**Addendum for Bid**  
**Taylor Street Water Quality Plan and Parking Lot Improvements**  
**14-871**

Date: October 1, 2013  
From: Stephanie Suter, CPPO, CPPB  
RE: Addendum No. 2

PROJECT:  
**TAYLOR STREET  
CITY OF LYNCHBURG  
ADDENDUM 2**

DATE: REV. 6-10-13  
 3-22-13  
 DRAWING No: S2  
 SHEET NUMBER: 2 OF 2

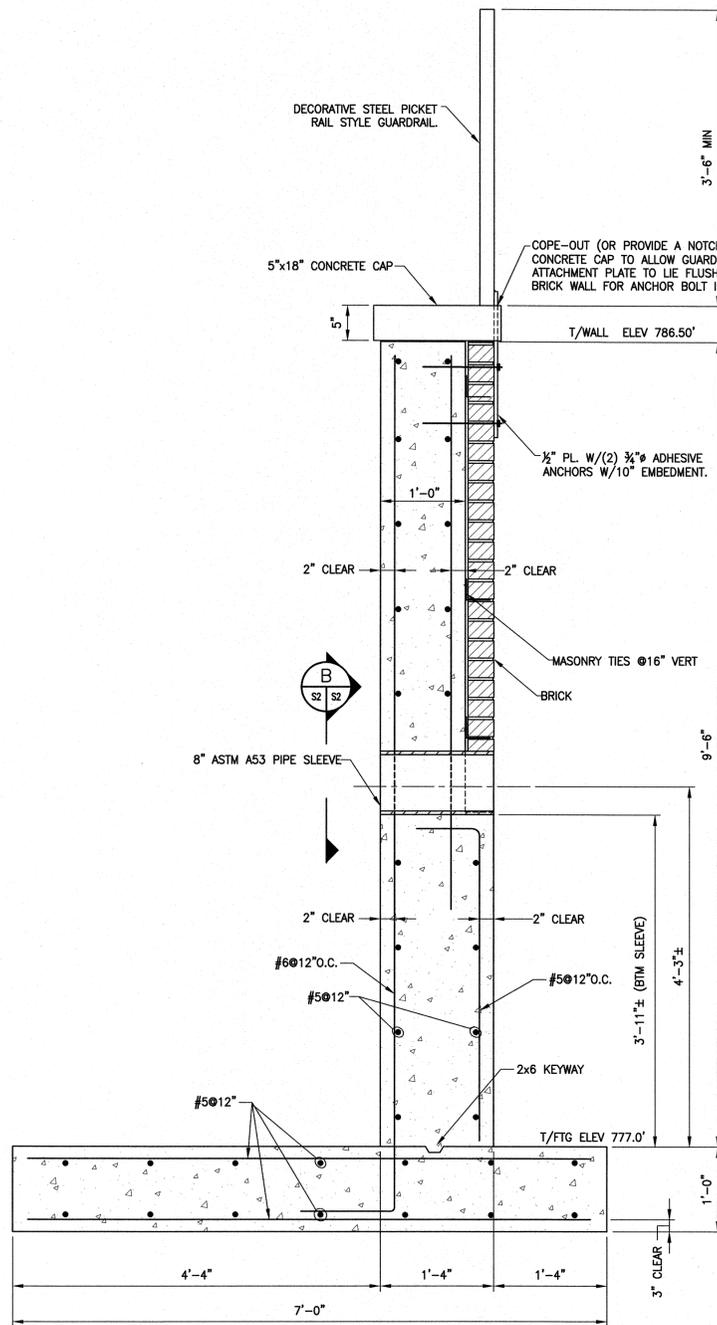
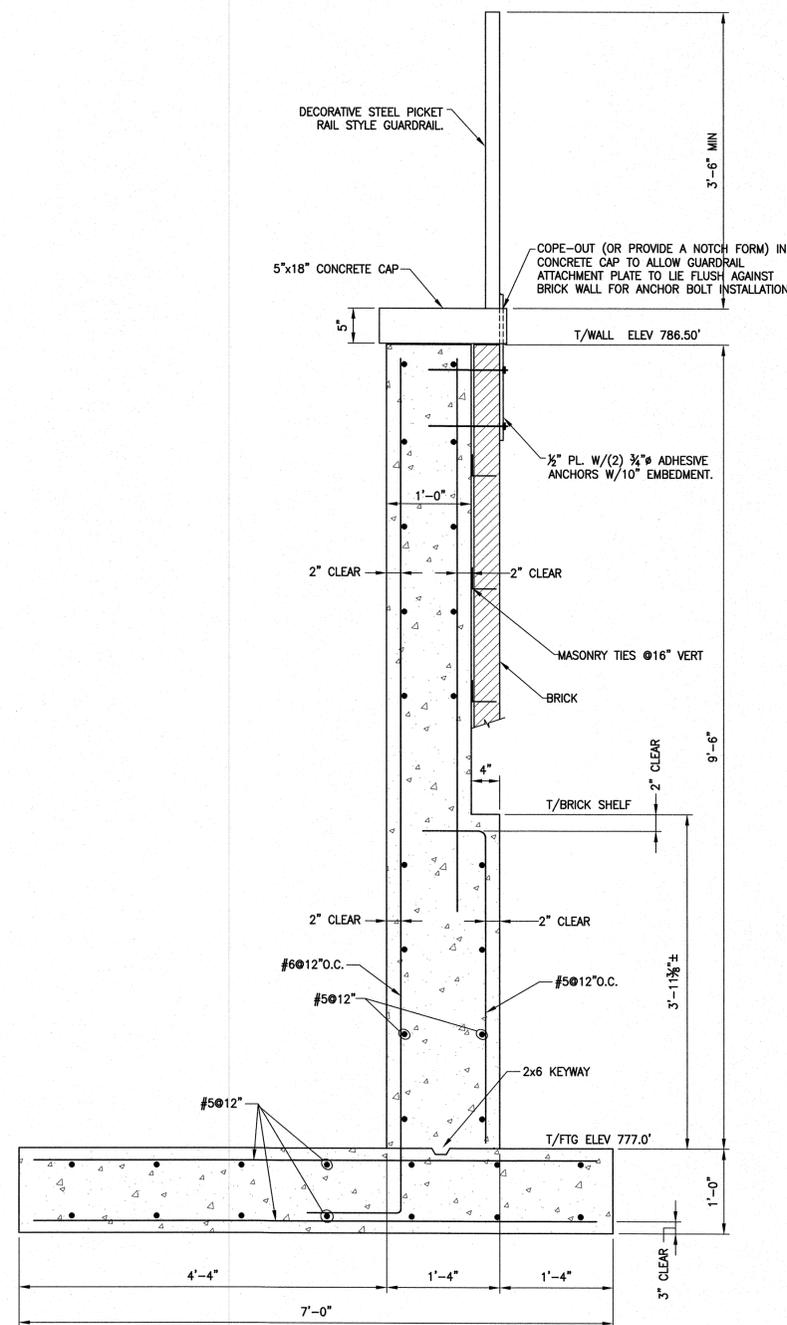
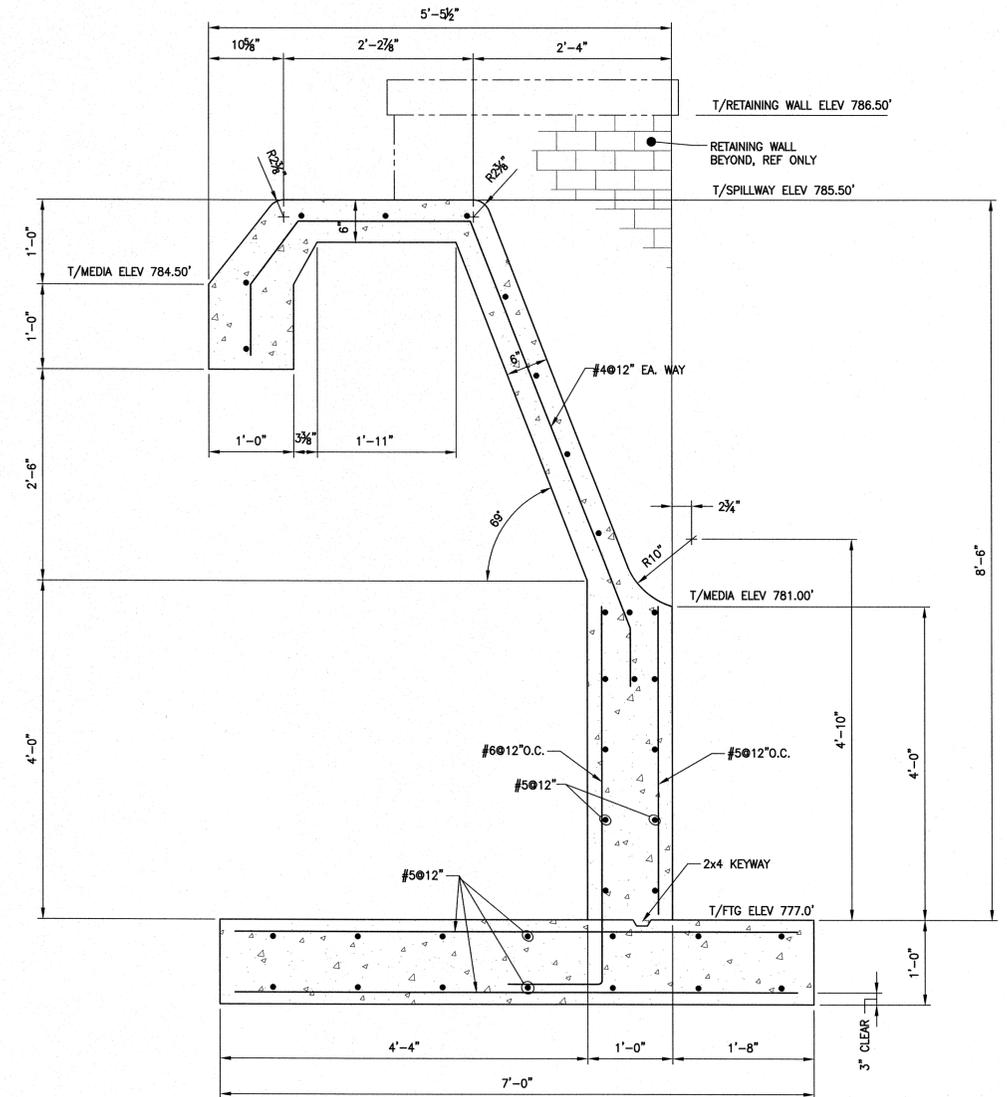
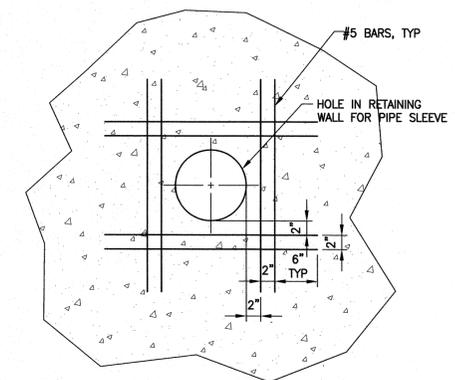
6. Two Structural Drawings S1 and S2 have been added to the Contract Drawings for the retaining walls and are attached. The wall details on Drawings S-1 and S-2 replace the details shown on Drawing D1. The picket railing shall match the ornamental railing of the plaza wall at the Fifth Street/Federal Street Roundabout. The brick shall match that of the original Filtration Plant Building. The concrete spillway shall have a cobblestone matte finish. A 4'x4' mock up of the brick and mortar along with a picture of the example cobblestone shall be submitted and approved by the City's construction coordinator.

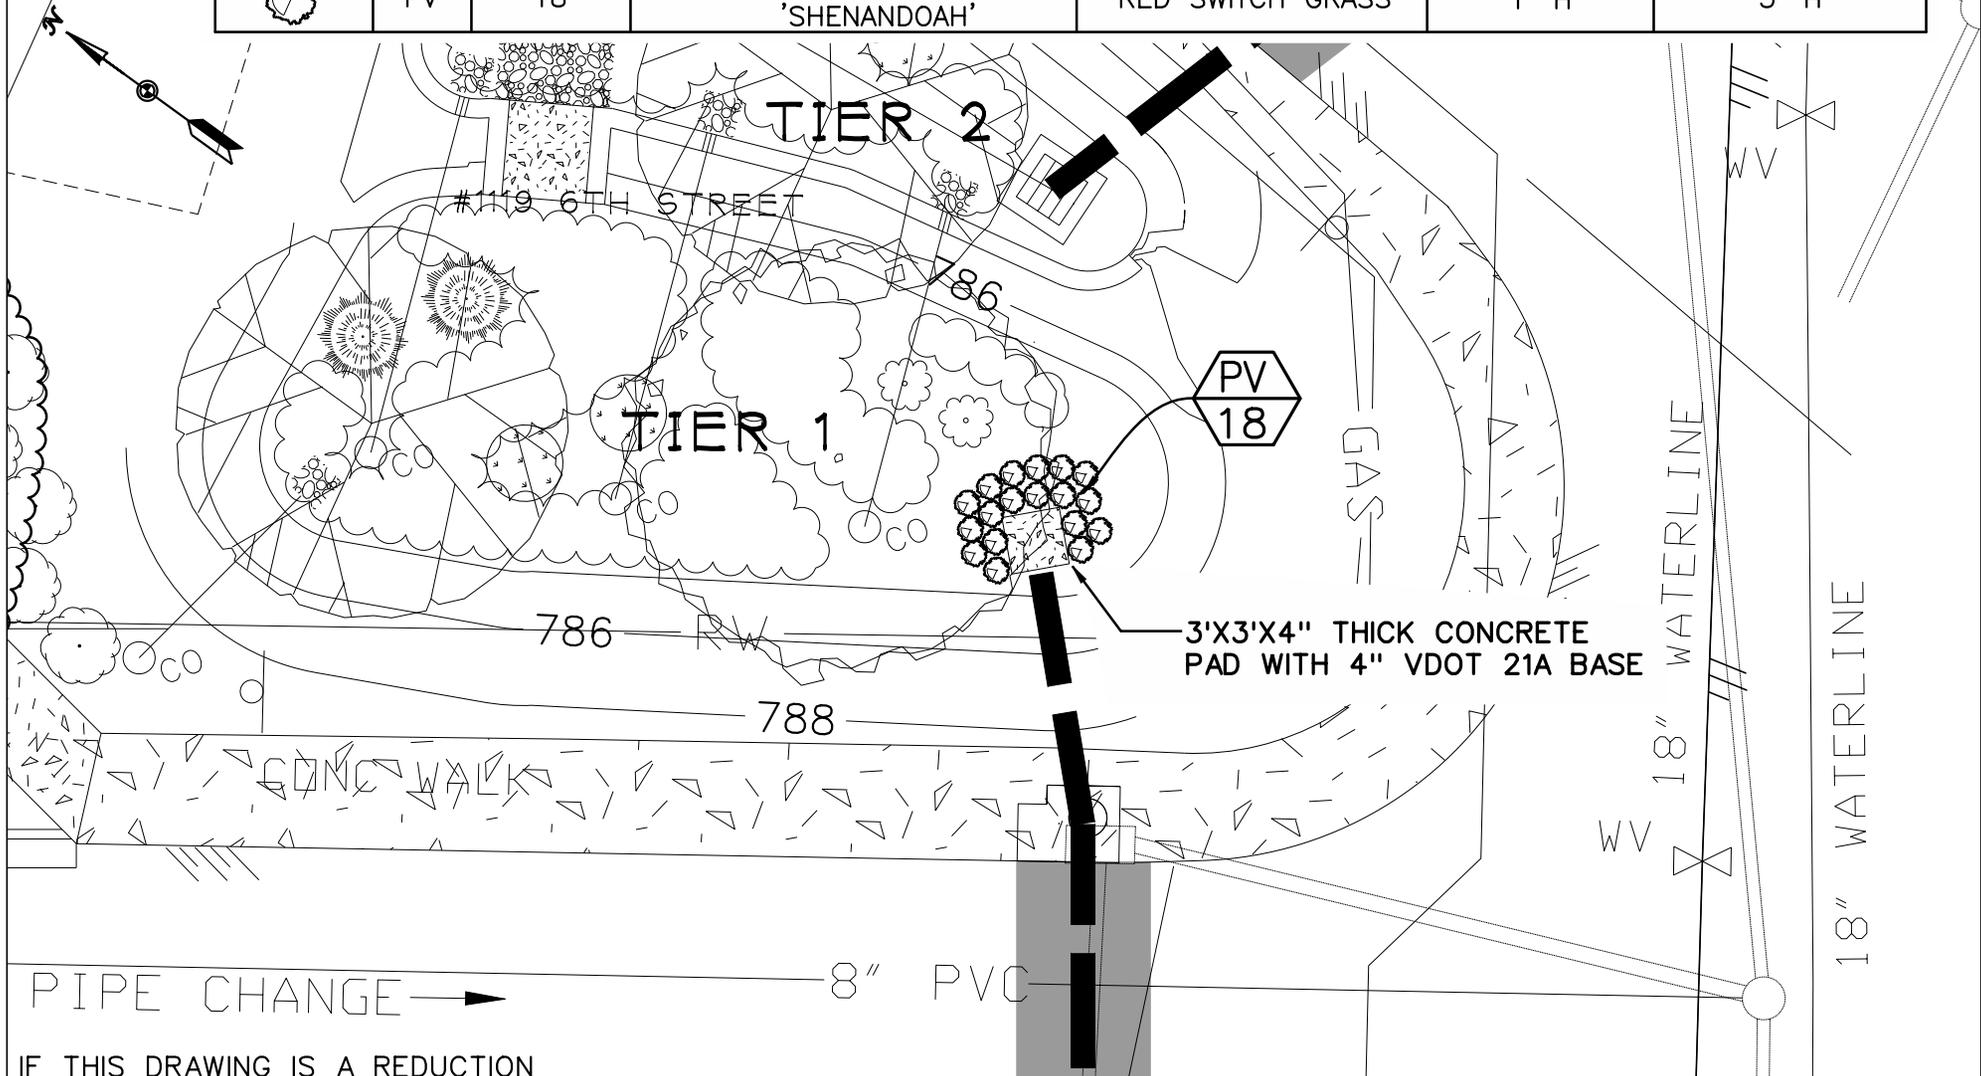
- c. 12" No. 57 Sub-Base; and
  - d. 190 LF - 6" HDPE Slotted and Solid Underdrains with Cleanouts (Note: The slotted underdrain will switch to solid pipe beyond the curb and gutter of the last parking space towards Park Avenue).

15. A detail has been added with this addendum that shows a different detail for the outfall from structure C-2. The previous plan used cobble rip rap at the outfall. The outfall will now have a 3' x 3' concrete pad poured at the outlet with a stone base. The quantity for the cobble rip rap has been reduced and the concrete pad quantity has been increased under the sidewalk line item. Incidentally, the river cobble sometimes referred to as river jack is to be a size equaling Class AI rip rap and be a rounded river rock. The plantings around the outfall have changed from 21 "Creeping Liriope" to 18 "Red Switch Grass".
16. The existing topographic survey was performed by Mike Cassidy at Piedmont Surveyors. Horizontal and Vertical Control can be sought from Mr. Cassidy at 434-426-9510.
